**MONTGOMERY COUNTY PLANNING DEPARTMENT**  
THE MARYLAND-NATIONAL CAPITAL PARK AND PLANNING COMMISSION

**MEMORANDUM**

**REVIEW TYPE:** Preliminary Plan of Subdivision and Preliminary Water Quality Plan

**PROJECT NAME:** McCormick's Addition to Horizon Hill

**PRELIMINARY PLAN**  
**McCORMICK'S ADDITION TO HORIZON HILL**  
**Montgomery County, Maryland**

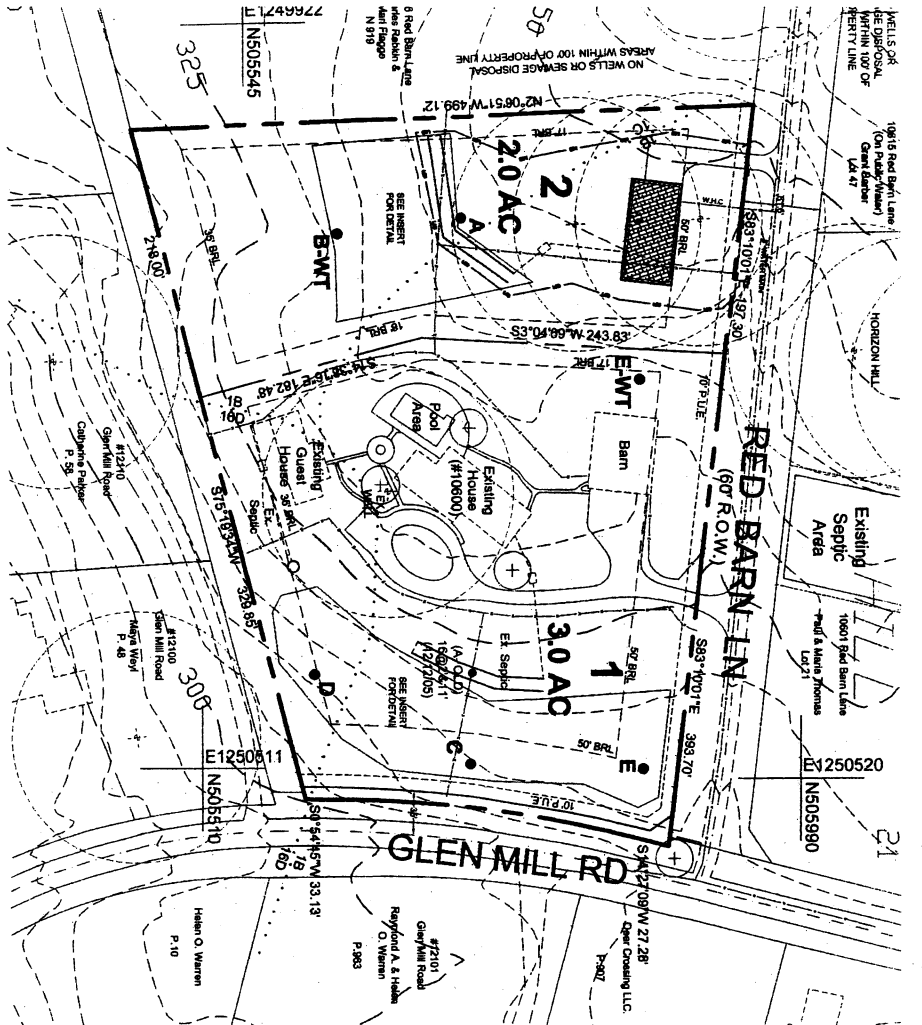
We have completed our review of the preliminary plan dated "September 2006". This plan was reviewed by the Development Review Committee at its meeting on 11/06/06. We recommend approval of the plan subject to the following comments:

1. Show all existing planimetric and topographic details specifically paving, storm drainage, driveways adjacent and opposite the site as well as existing rights of way on both sides and easements on the preliminary plan.

2. Right of way dedication for Glen Mill Road per Master Plan.
3. Grant necessary slope and drainage easements. Slope easements are to be determined by study or set at the building restriction line.

4. We did not receive complete analyses of the capacity of the downstream public storm system(s) and the impact of the post-development runoff on the system(s). As a result, we are unable to offer comments on the need for possible improvements to the system(s) by this applicant. Prior to approval of the record plat by the Department of Permitting Services (DPS), the applicant's consultant will need to submit this study, with computations, for review and approval by DPS. Analyze the capacity of the existing downstream public storm drain system and the impact of the post-development ten (10) year storm runoff on same.
